**SECTION 00 90 02
BIDDING AND CONTRACT REQUIREMENTS
ADDENDUM NUMBER 2**

Issued: May 12, 2023

Re: ADDENDUM NUMBER (2) TO THE BIDDING DOCUMENTS FOR

**McHenry County College
Visiting Team Changing Rooms**
Architect's Project Number: 23-006

SHEET NUMBER:
AD1.10

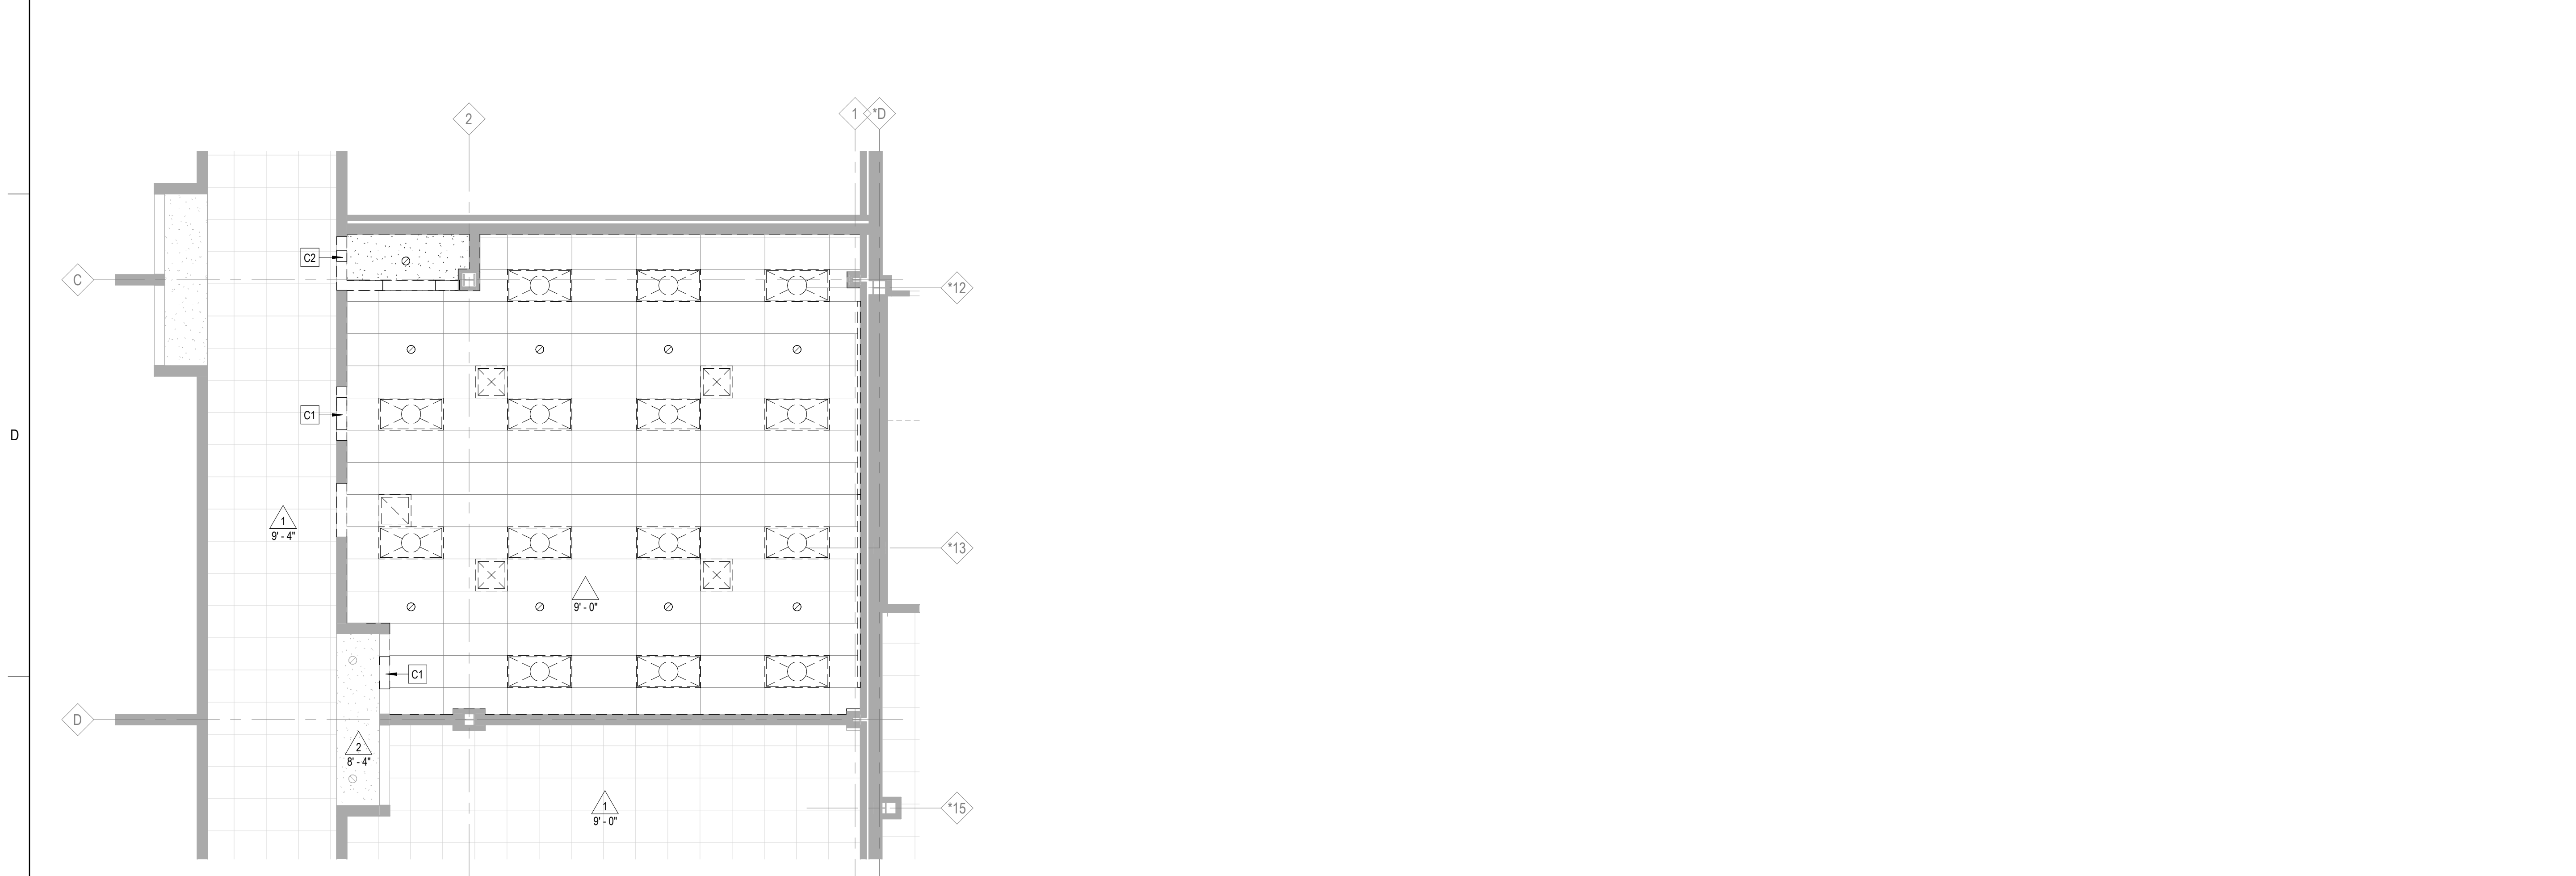
1. AD1.10
 - A. **REVISE** demolition reference note M4 as indicated.
2. A1.10
 - A. **REVISE** floor plan reference note 2 as indicated.
 - B. **ADD** floor plan reference note 10 as indicated.
 - C. **REVISE** reference note 5 to reference note 10 in rooms A103A and A103C as indicated.
 - D. **REVISE** light fixture layout per changes made to the electrical drawings.
3. E1.10
 - A. **REVISE** “ELECTRICAL DEMOLITION PLAN” to disconnect and remove all existing luminaires.
 - B. **REVISE** “LIGHTING PLAN” to show new luminaires.
 - C. **ADD** “LUMINAIRE SCHEDULE” as indicated.

M4. MARKER BOARDS TO BE REMOVED BY OWNER AND PROVIDED TO CONTRACTOR FOR RE-INSTALLATION IN NEW WORK.
